### Service Instructions MR013/04/I

Title: Optional 80K shield temp alarm adapter

Fig. 3 Cable adapter 617-175 wiring schematic

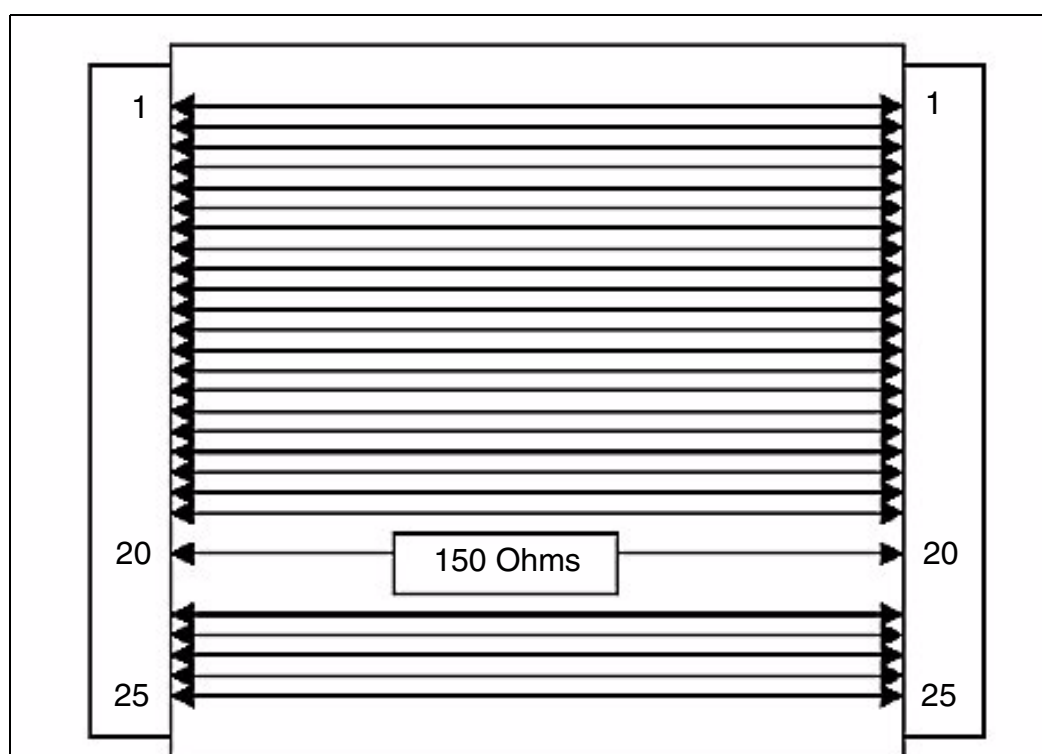
The cable adapter 617-175 has been designed to reduce the voltage output from the 80k shield measurement in order to produce a lower input to the alarm trip on the control crate unit.

The 25 way adapter cable has a 150 ohm resistor fitted inside , across the wire going between pins 20 ([Fig. 3](#)). The male and female plug and socket are wired pin for pin except on pin 20 which has the 150 ohm resistor in line.

This resistor will reduce the 80k shield temperature reading on the control crate by 12 - 15k.

1. A Label was added to the kit.
2. The serial number range of the affected systems was changed.
3. The resistance of the adapter was changed from 470 Ohms to 150 Ohms.

Fig. 4 Temp adapter 617-175 plugged on CCA cabinet

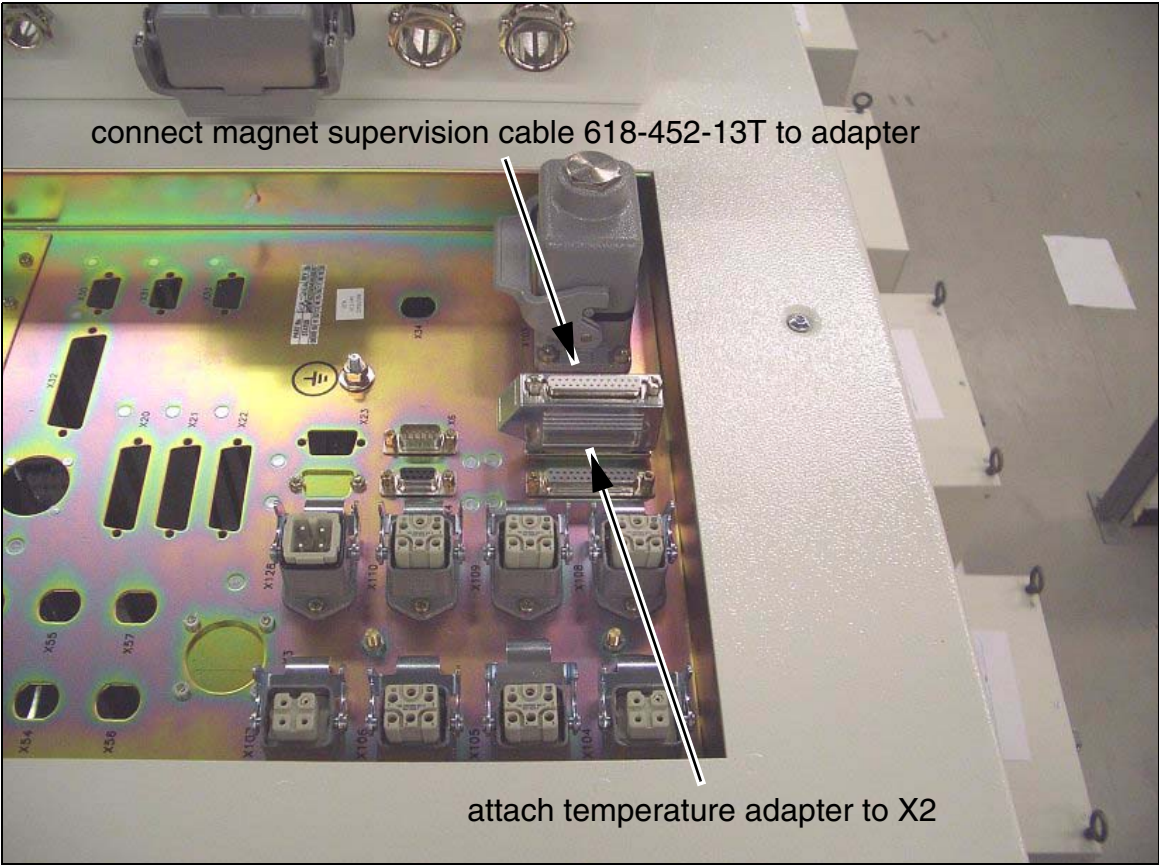
- Remove magnet supervision cable (618-452-13T) from X2 connector on top of the CCA cabinet.
  - ⇒ An alarm will come up at the alarm box, please acknowledge. Connect the male plug of the temp adapter to the X2 socket located on the top of the K2201 cabinet (Fig. 4).
  - ⇒ Make sure the locking screws are tightened.
- Reconnect the magnet supervision cable (618-452-13T) from the filter panel to the female socket of the temp adapter.
- Reconnect connector "B" at magnet service turret.
- Fit label inside the CCA cabinet as shown in Fig. 5.
